**TOWN OF NEWBURGH
PLANNING BOARD
TECHNICAL REVIEW COMMENTS**

PROJECT: GARDNERTOWN COMMONS
PROJECT NO.: 2016-03
PROJECT LOCATION: SECTION 75, BLOCK 1, LOT 21
REVIEW DATE: 28 APRIL 2017
MEETING DATE: 4 MAY 2017
PROJECT REPRESENTATIVE: JCM PLANNING ENGINEERING

RE: JMC Project 15155
 Gardnertown Commons
 Gardnertown Road
 Town of Newburgh, NY

SHEET: SP-12
 DATE: 02/19/2016
 PROJECT: 15165
 DRAWING: SET 2

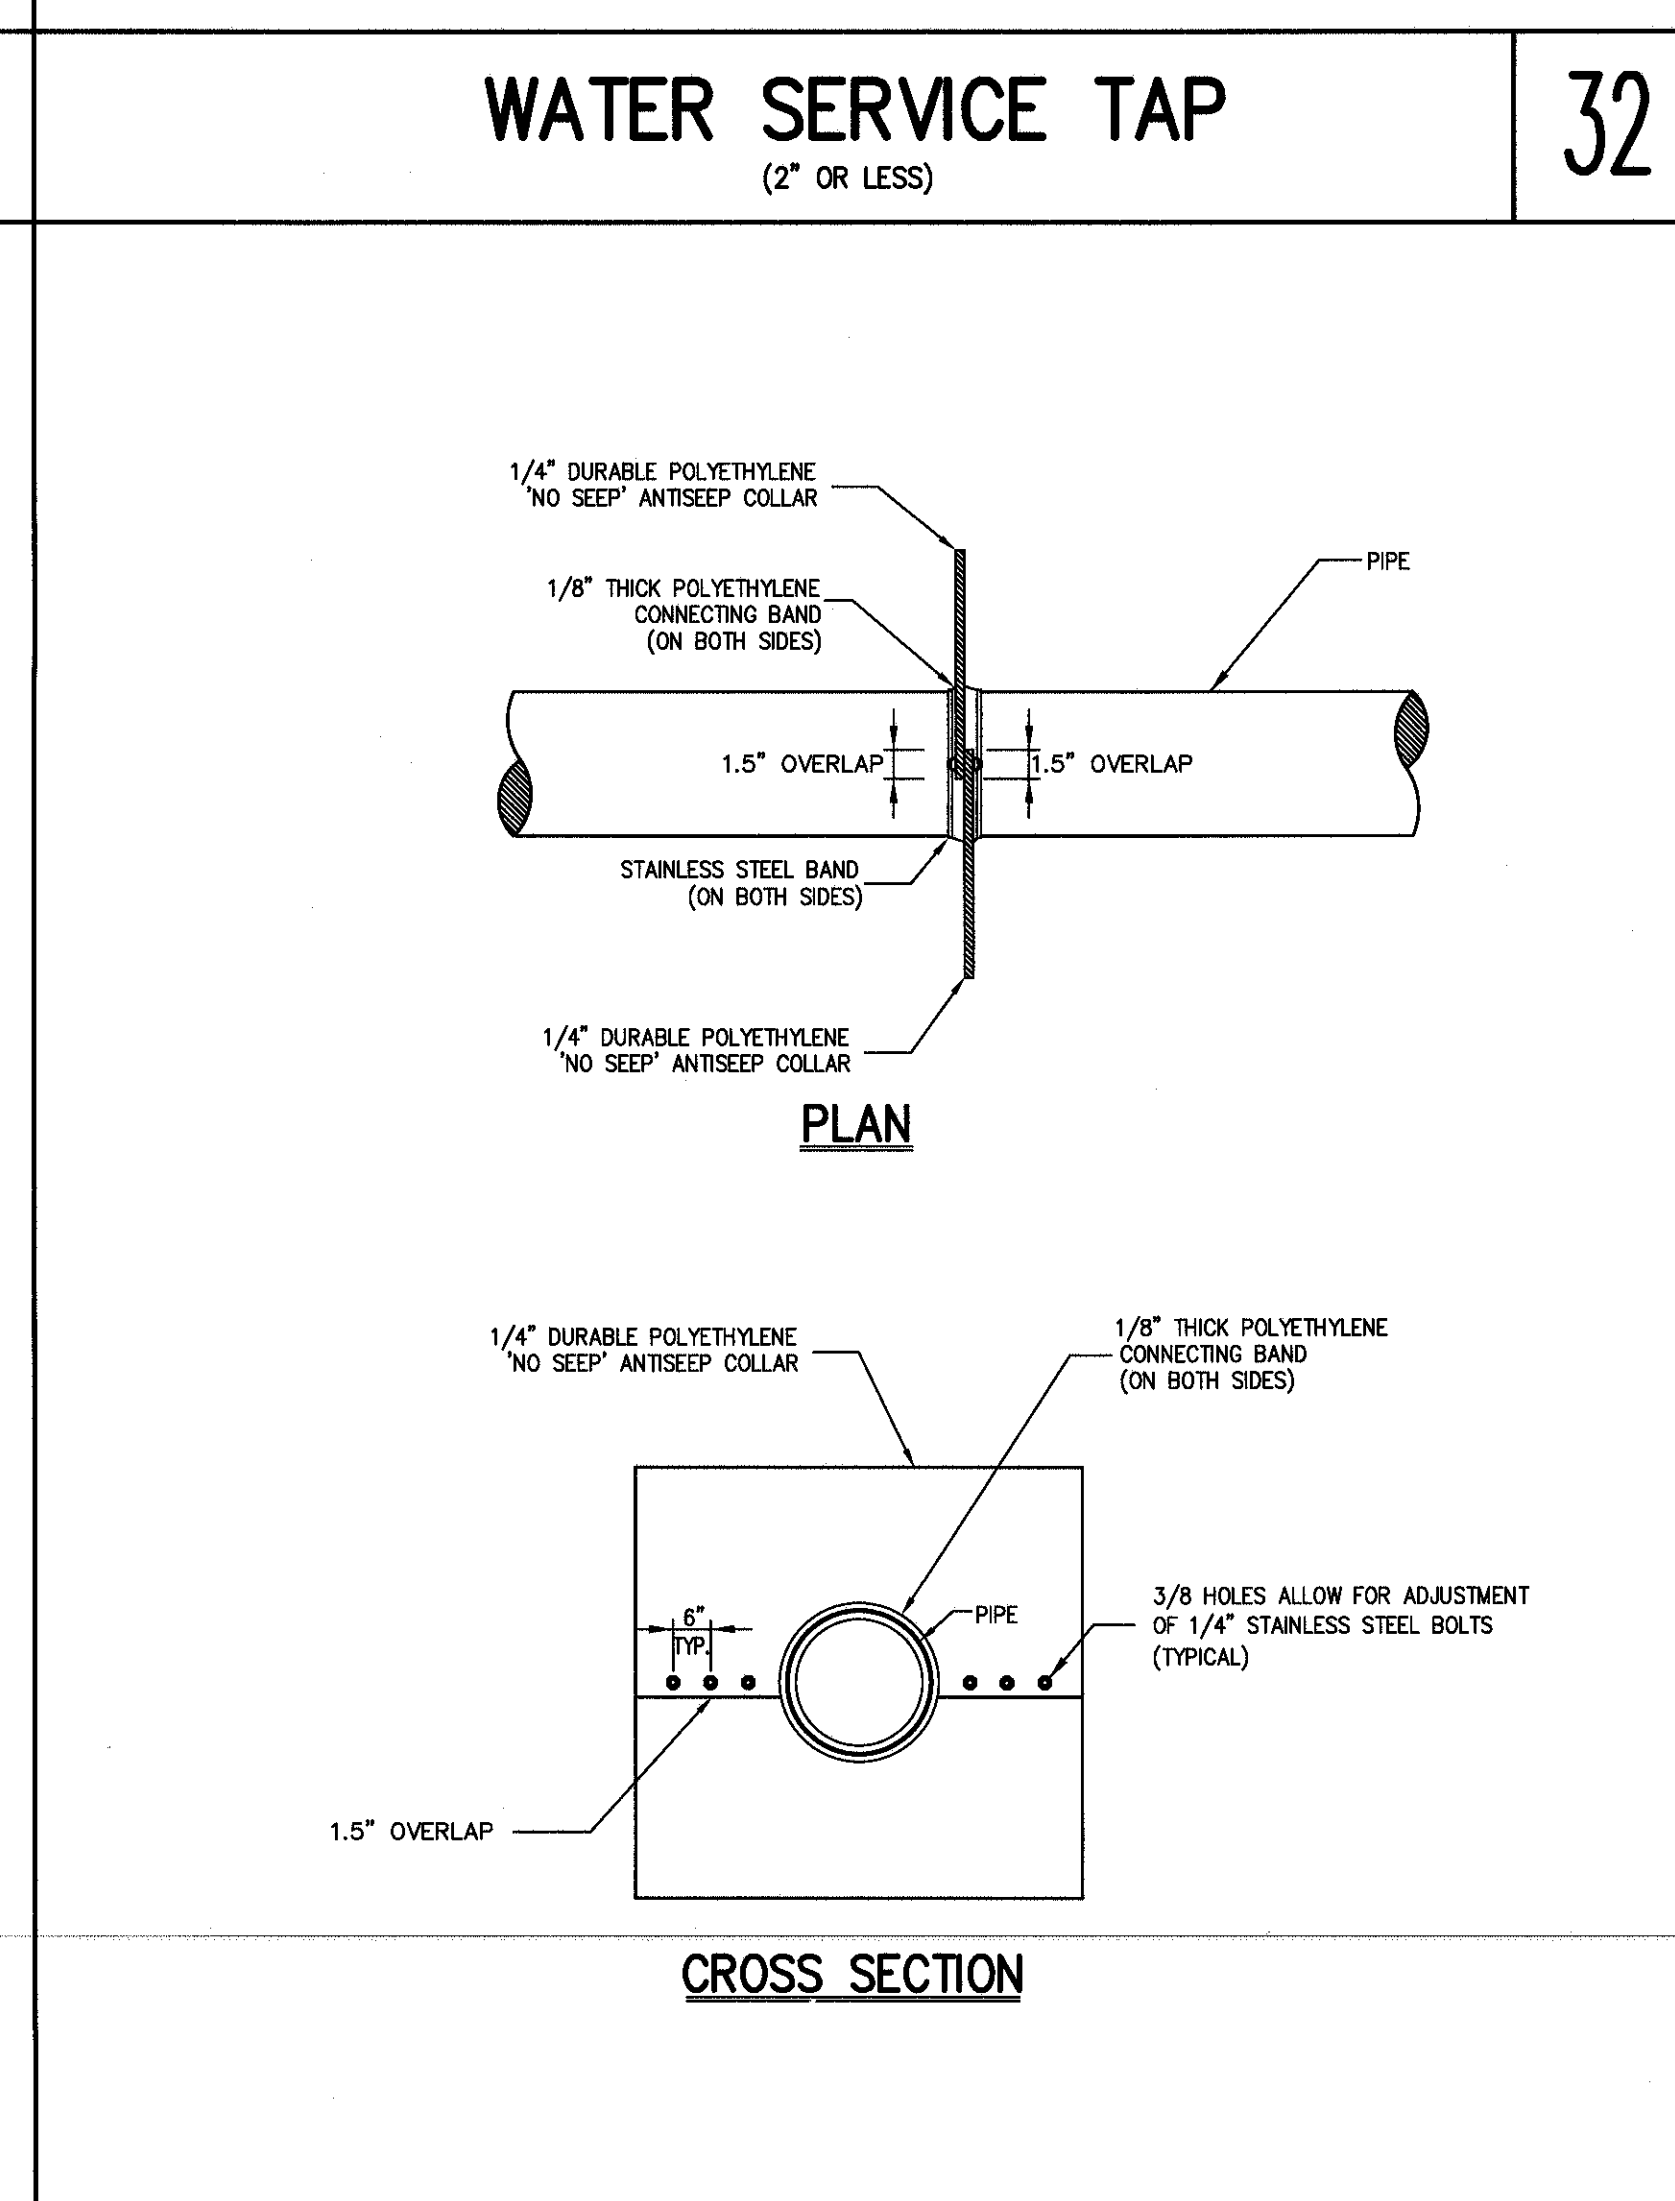
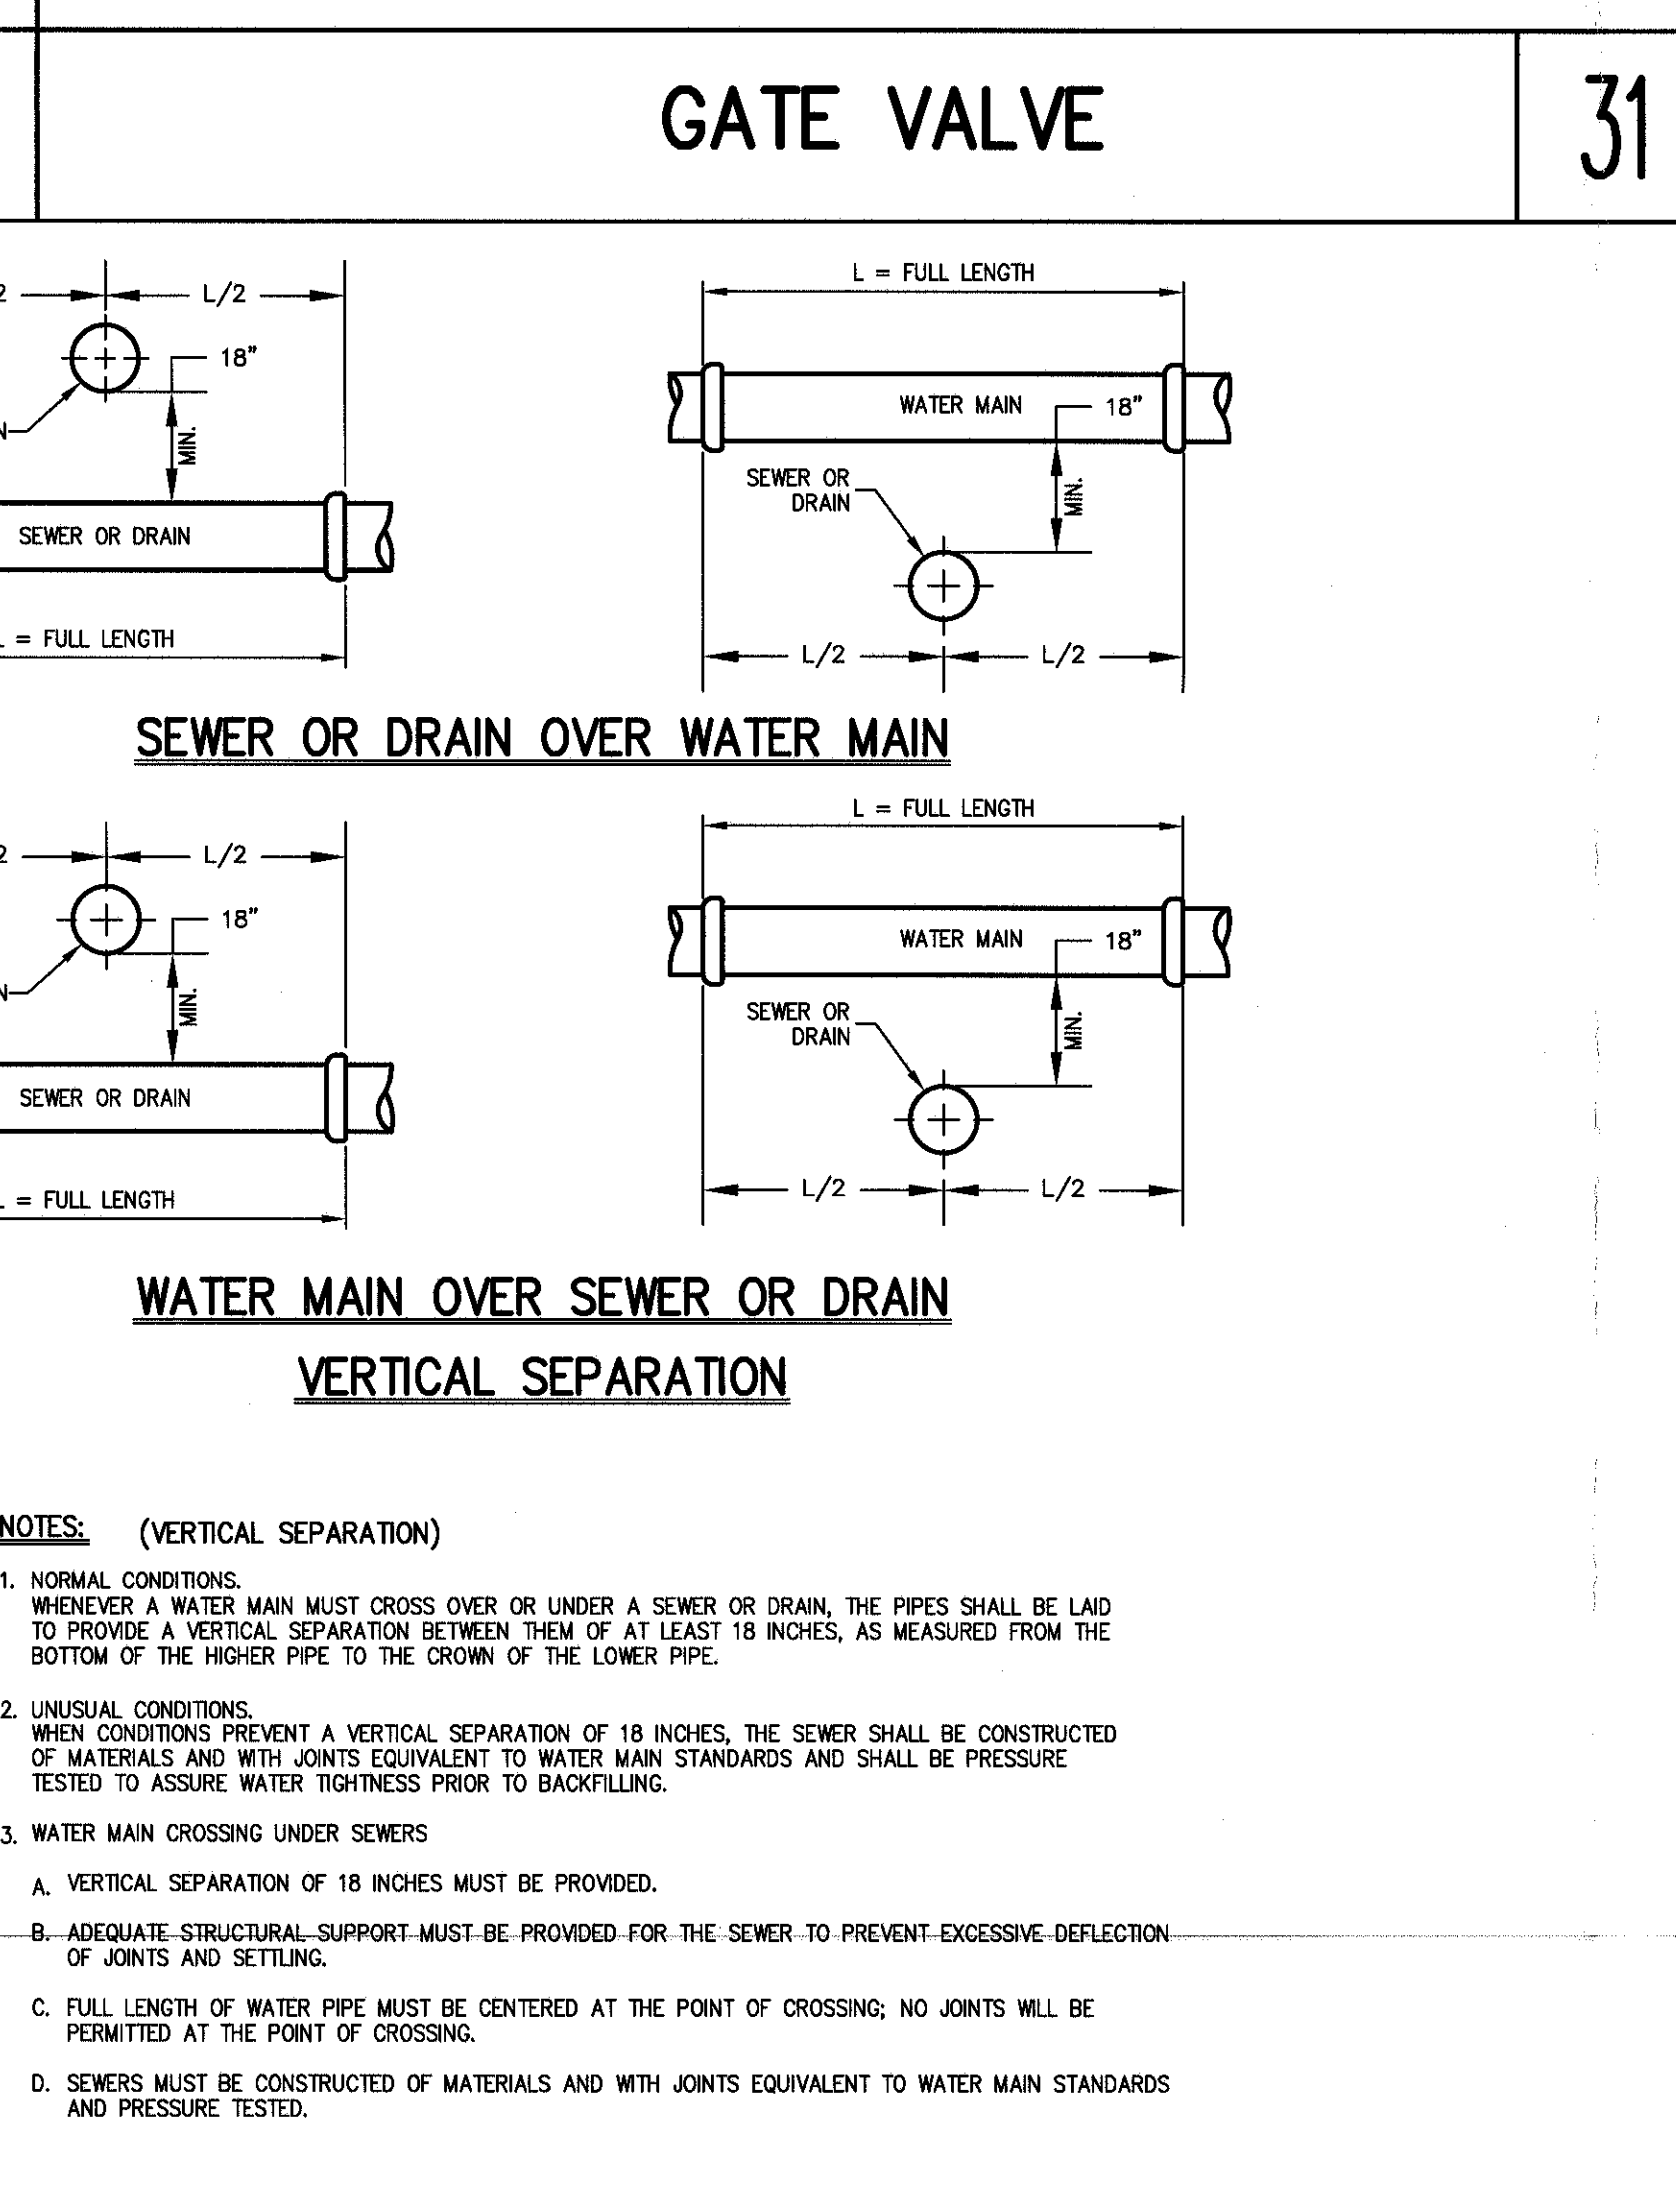
- d. Structure ID-WO identifying an elevation of 256.35 is identified with a similar 16 ft. weir length. It appears from the detail that this is a 16 in. +/-weir length identified at 1.4 ft. in the outlet control structure detail.

- f. *The stormwater model contains seven- 6 in. diameter orifices located at 252.3. These orifices are not depicted in the detail. The detail depicts a 1.4 ft. weir at that elevation.*

Detail #25 on sheet SP-12 has been updated to correctly so the elevation, weir, and orifi dimensions for OCS-F-4.

The orifices are now clearly shown in detail #25 on sheet SP-12.
